CITY PLAN COMMISSION**THURSDAY, MARCH 20, 2025****FILE NUMBER:** S245-107**SENIOR PLANNER:** Sharmila Shrestha**LOCATION:** Johnson Lane, north of Persimmon Road**DATE FILED:** February 19, 2025**ZONING:** R-7.5(A)**CITY COUNCIL DISTRICT:** 8**SIZE OF REQUEST:** 2.0-acres**APPLICANT/OWNER:** Manuel Aguilera

REQUEST: An application to create one 0.505-acre lot, one 0.575-acre lot, and one 0.920-acre lot from a 2.0-acre tract of land in City Block 6879 on property located on Johnson Lane, north of Persimmon Road.

EXISTING AREA ANALYSIS MAP

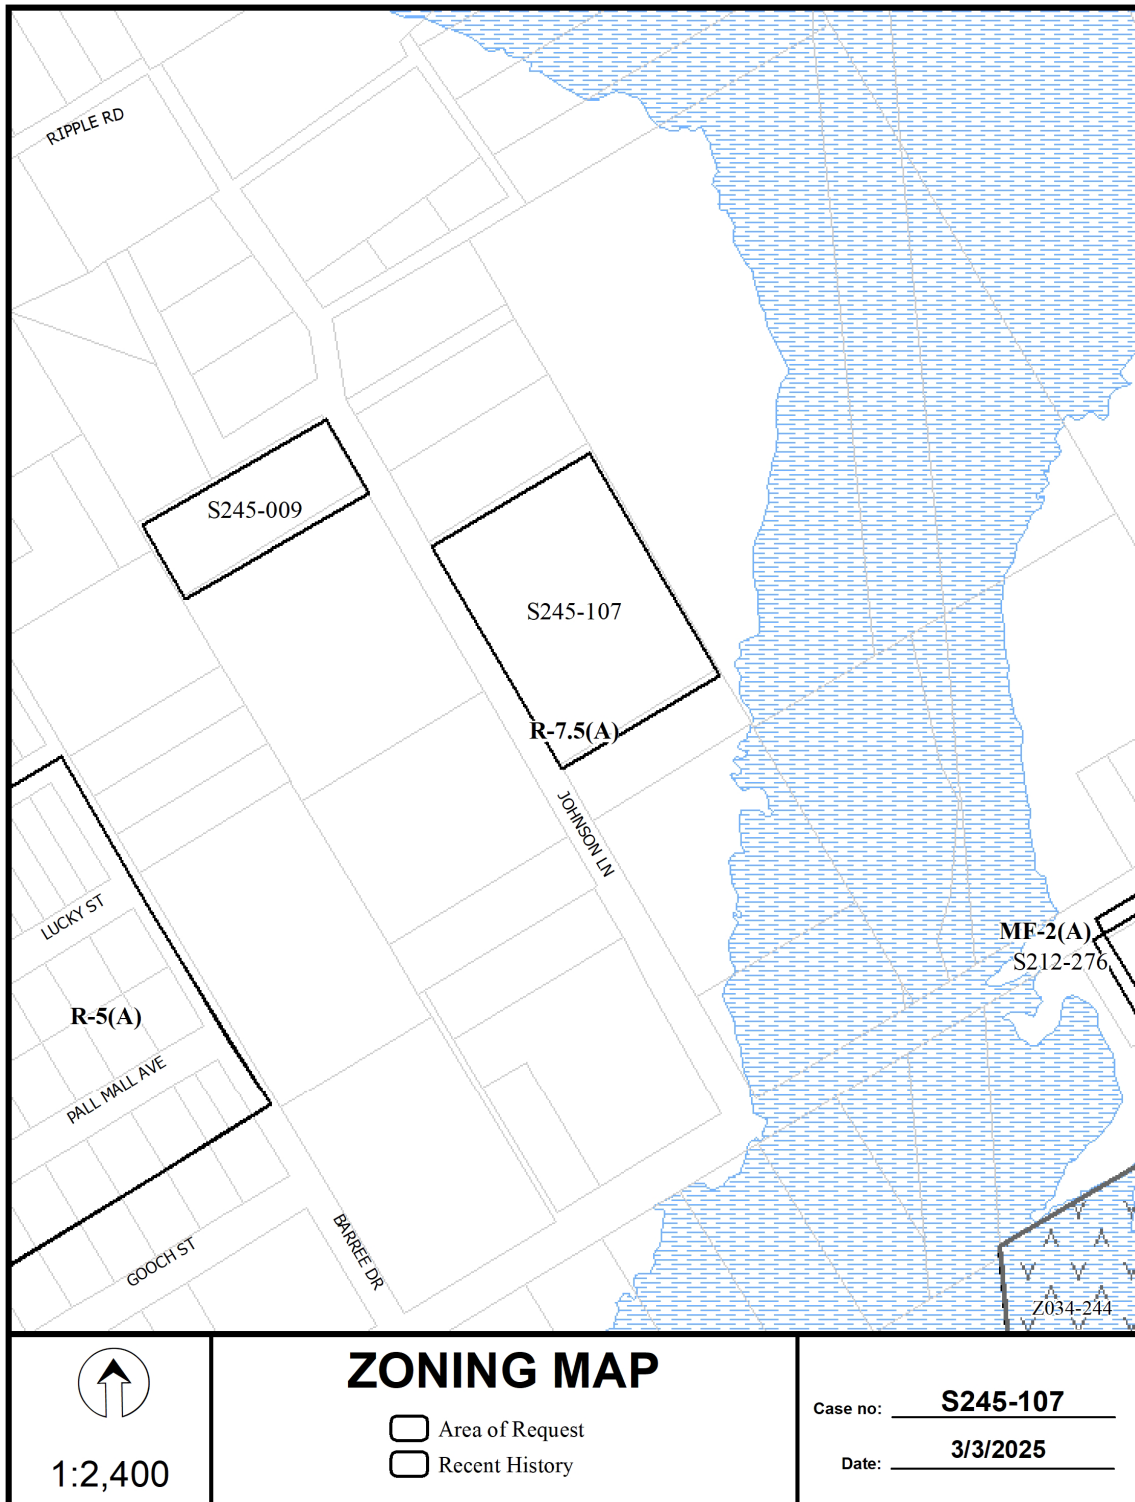
- The properties to the north, east, south, and west of the present request have areas ranging in size from 21,009 square feet to 283,225 square feet and are zoned R-7.5(A) Single Family District. *(Refer to the existing area analysis map).*
